LOT NUMBER	PHASE	HOUSE TYPE	REG. PLAN #	CLOSING DATE
36 Marbrook	1	40-5 ELEV A OPT. 2ND FLOOR	65M-4403	
INV#	QTY	EXTRA / CHANGE

Marbrook

36 Marbrook

40-5, Elev. A, Opt. 2nd Floor

GROUND FLOOR ELEV. 'A'

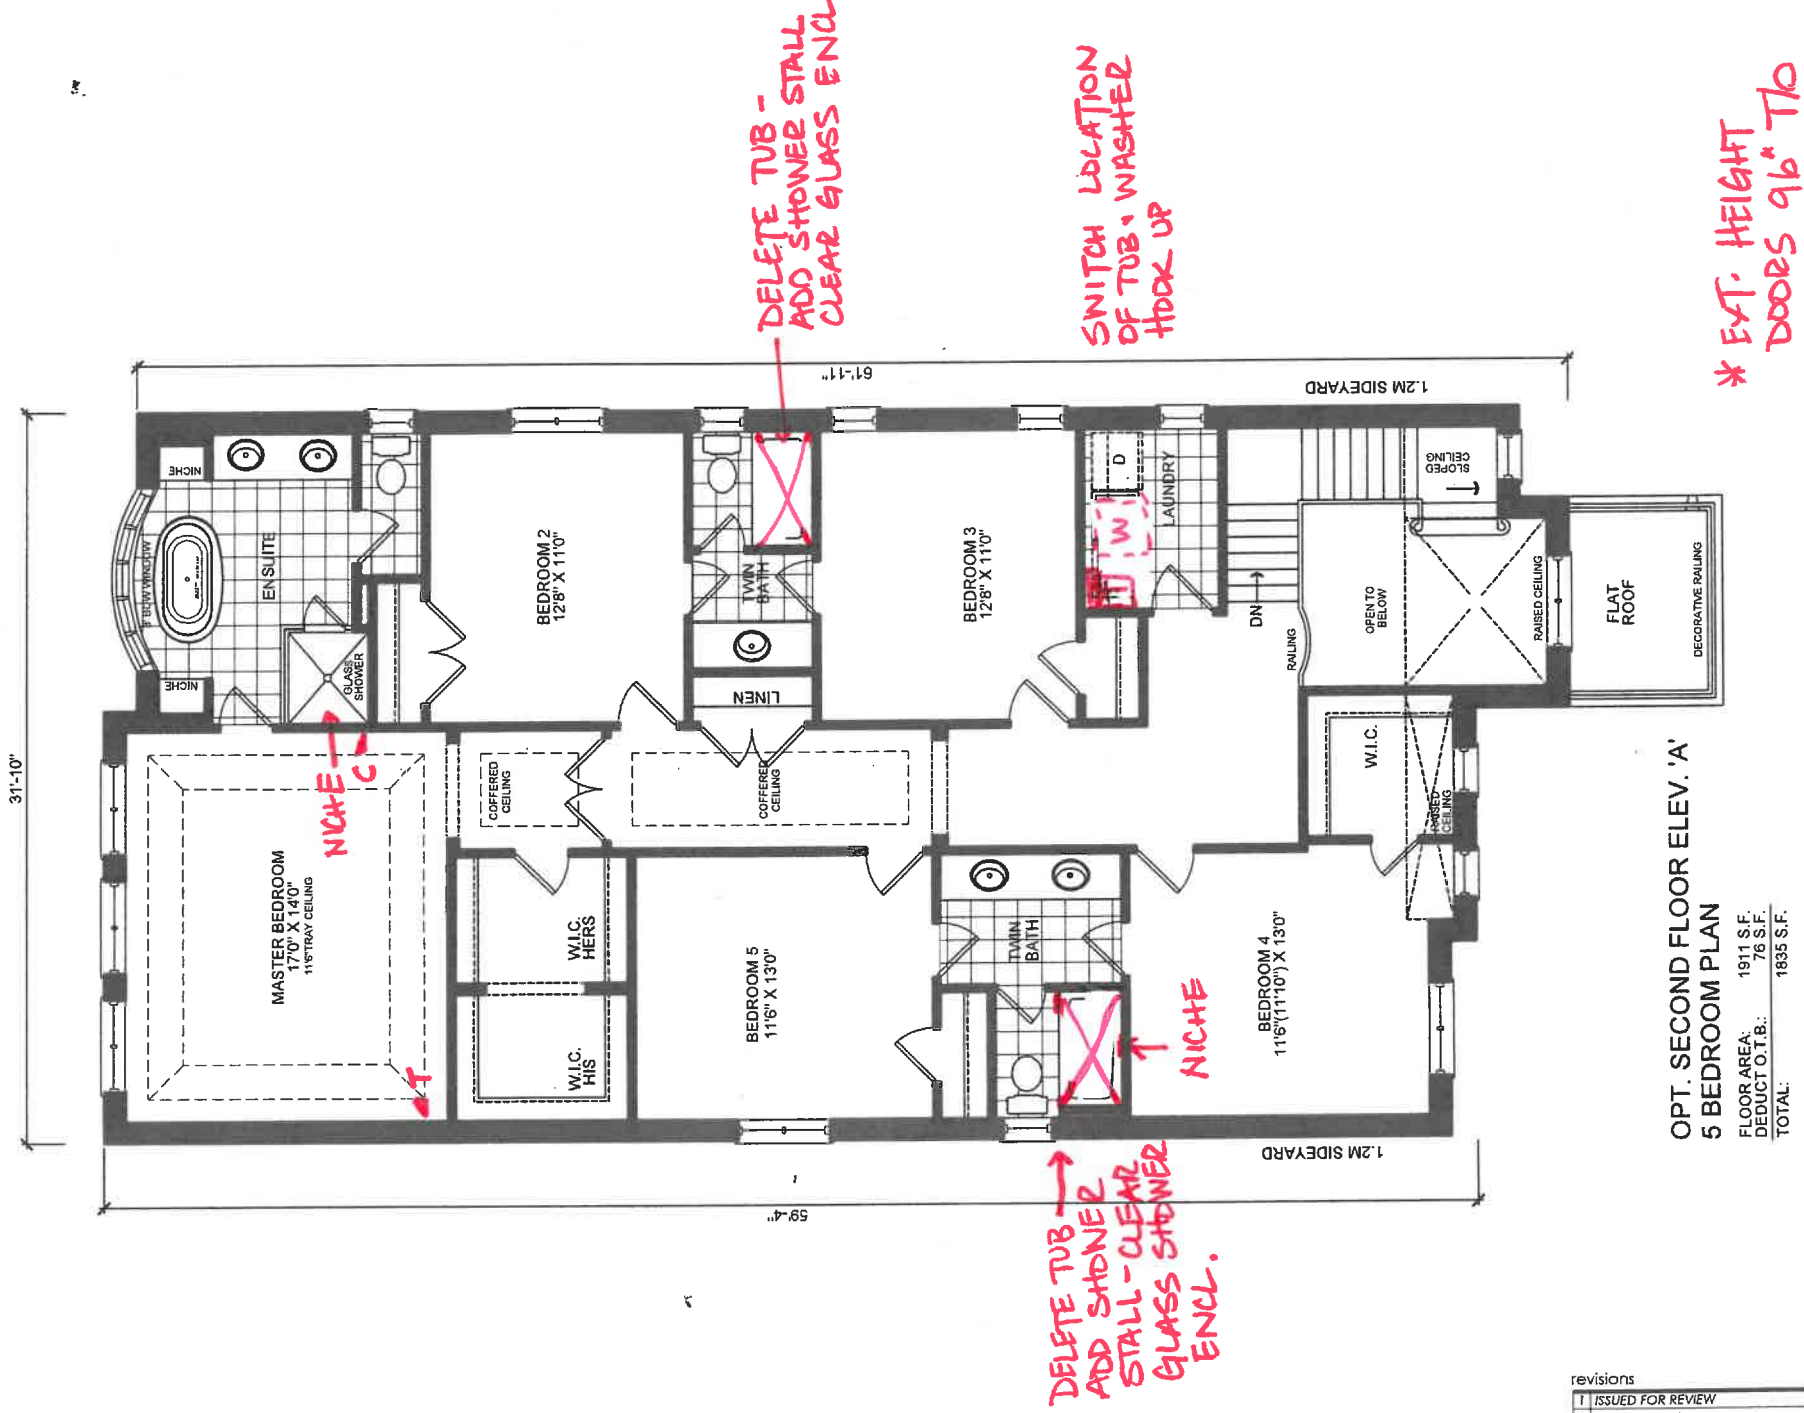
2,044 21Sep21	✓ Note:	1 - SWITCH LOCATION OF LAUNDRY TUB AND WASHING MACHINE HOOK UP IN LAUNDRY ROOM	9227
------------------	------------	--	------

2,044 21Sep21	✓ Note:	1 - INSTALL EXTENDED HEIGHT DOORS THROUGHOUT 2ND FLOOR TO 96"	9228
2,044 21Sep21	✓ Note:	1 - REDUCE SIZE OF BULK HEAD IN KITCHEN TO SMALLEST SIZE POSSIBLE (10-12") CABINETRY IS STANDARD HEIGHT AND WILL NOT BE ATTACHED TO THE BULK HEAD OPEN SPACE WILL REMAIN ABOVE CABINETRY Note: FULL BULK HEAD CANNOT BE REMOVED DUE TO PLUMBING PIPES ABOVE	9229

OPT. SECOND FLOOR ELEV. 'A'
5 BEDROOM PLAN

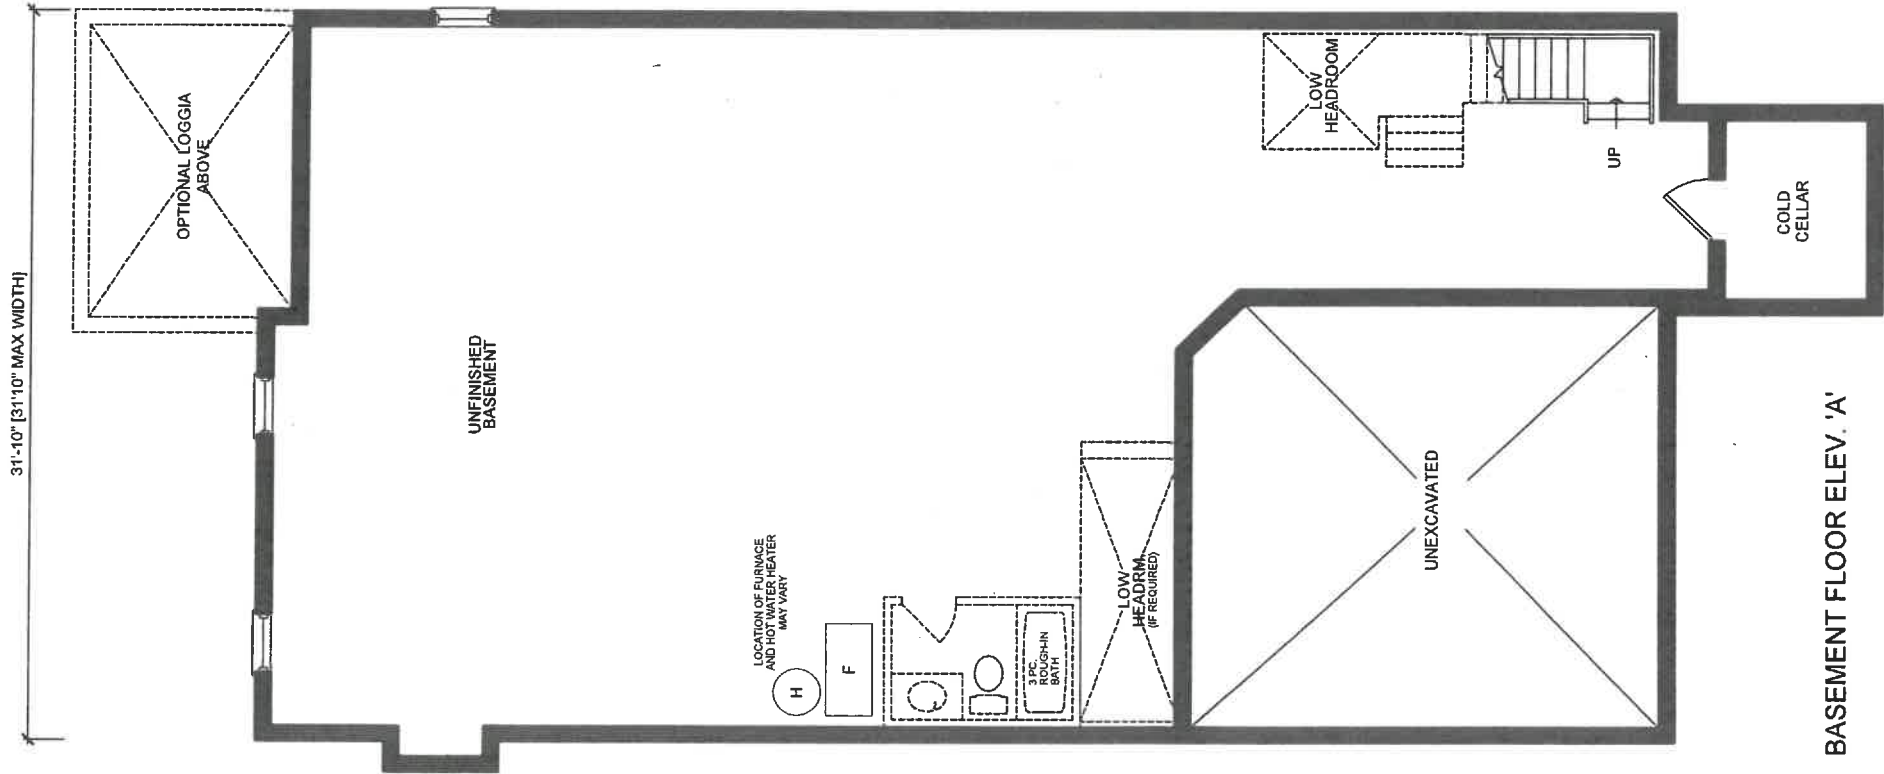
2,044 21Sep21	✓ Note:	1 - INSTALL NICHE IN MASTER ENSUITE SHOWER STALL BUILDER STYLE IN WHITE	9225
2,044 21Sep21	✓ Note:	1 - INSTALL NICHE IN SHOWER STALL IN SHARED BATHROOM (BEDROOM 4 AND 5) BUILDER STYLE IN WHITE

2,044 21Sep21	✓ Note:	2 - REPLACE STANDARD TUB IN BOTH TWIN ENSUITE BATHROOMS WITH SHOWER STALL WITH CURB AND CLEAR GLASS FRAMELESS SHOWER ENCLOSURE WITH DOOR AND GLASS PANEL STANDARD CHROME HINGES AND HANDLE (UNLESS OTHERWISE NOTED AT STAGE 2)	9226
------------------	------------	--	------
